## Service Information No. 09 / 04

### New sealing ring for pushrod guide on the cooling collar **M43**

Figure 1

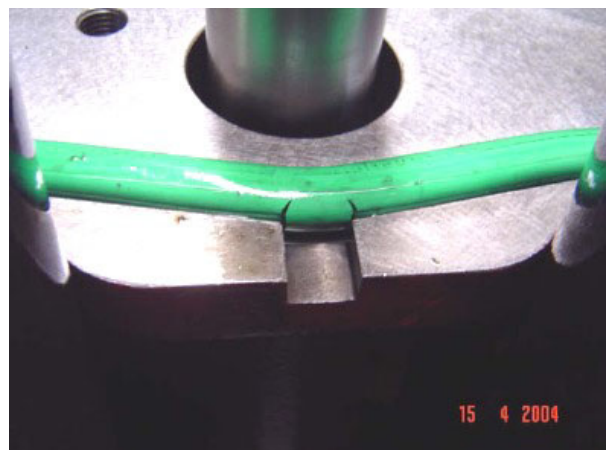
On the pushrod guide of the cooling collar there occurred some isolated instances of oil leaks in the area of the cylinder head connection point. In the course of time the sealing ring lost its sealing capability. A new solution has already been implemented in the current series production (VM43, M43, M43C).

As a new feature this sealing arrangement will now include a thicker Viton sealing ring. For subsequent mounting of this new sealing ring it is necessary to carry out the following modification on the cooling collar:

The edges of the oil drain are to be rounded with radius  $r = 4$  mm (see figure 1). This can be carried out by means of a metal removing tool such as a pneumatic cutter, a grinding tool or a file.
